REQUEST FOR BID
#14-0070
MAINTENANCE BUILDING SEDGWICK COUNTY PARK

ADDENDUM #3

Addendum Number Three
To The Drawings and Specifications for
SEDGWICK COUNTY PARK
Phase I - MAINTENANCE BUILDING

Issued: Wednesday, August 27, 2014

SHEET
SP1.4

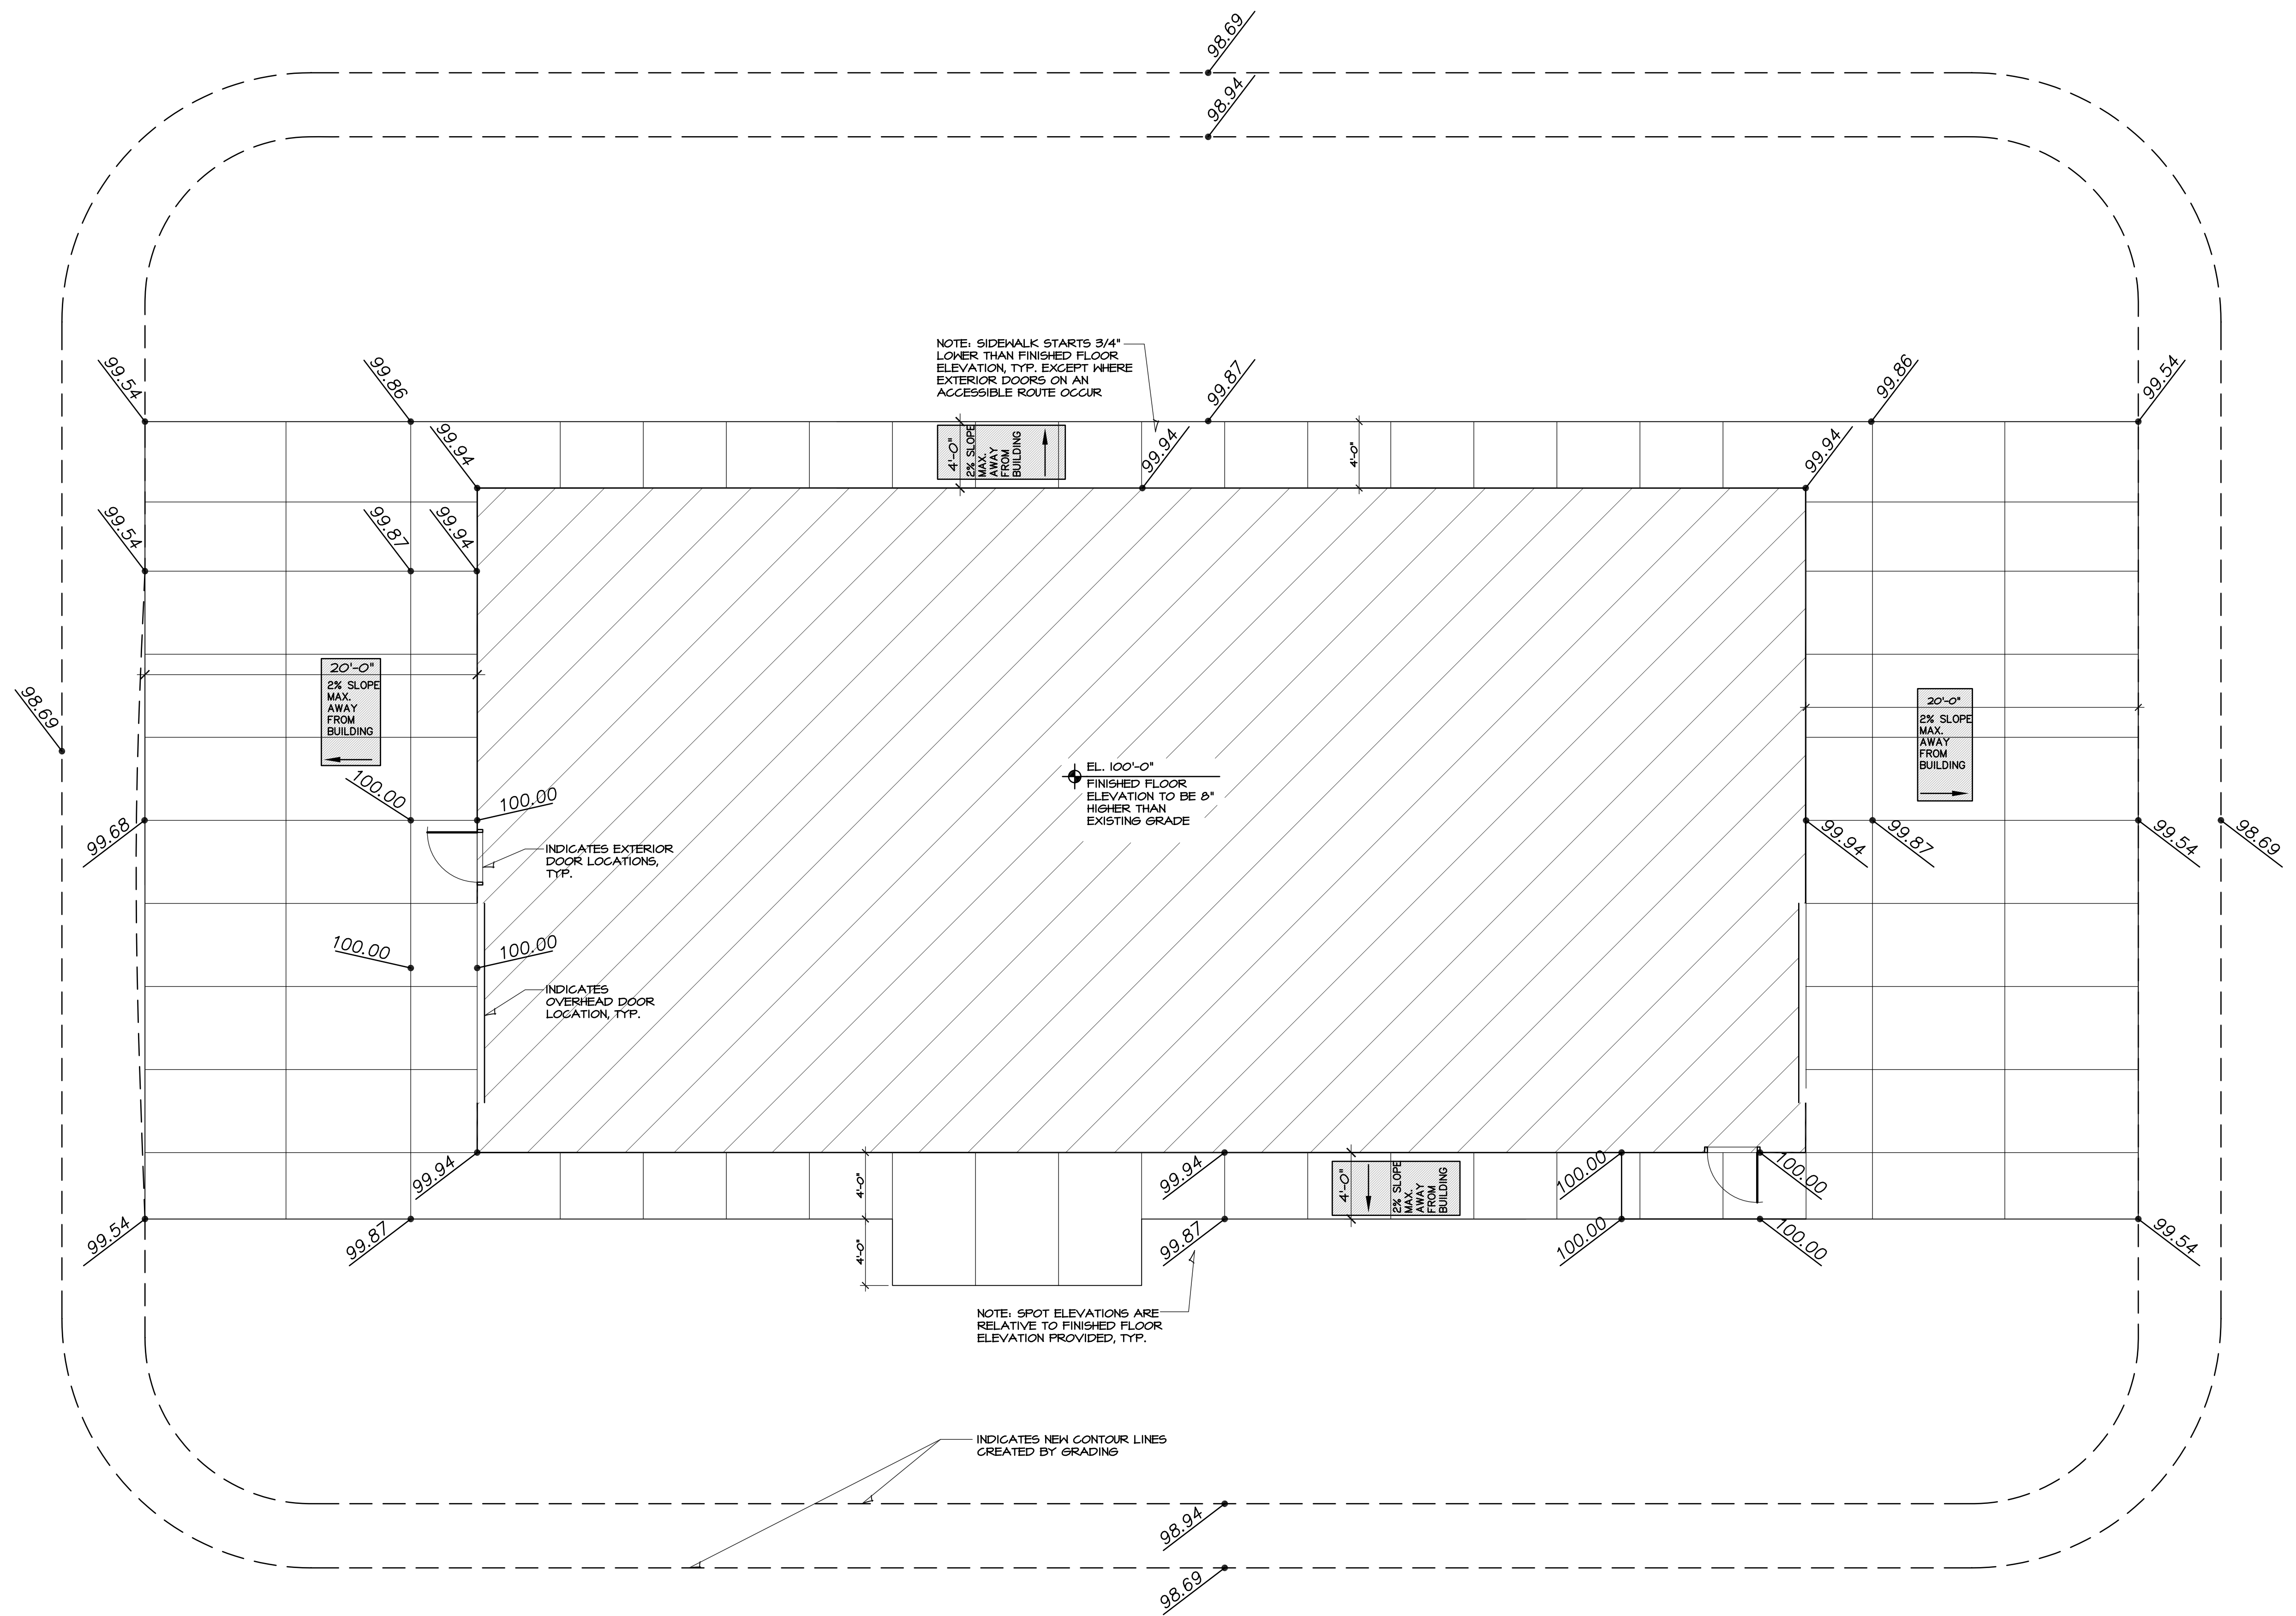
A new sheet SP1.4 has been prepared to illustrate the finish grades we want for this project. The sheet has been added to this document and shall be considered part of this addendum.
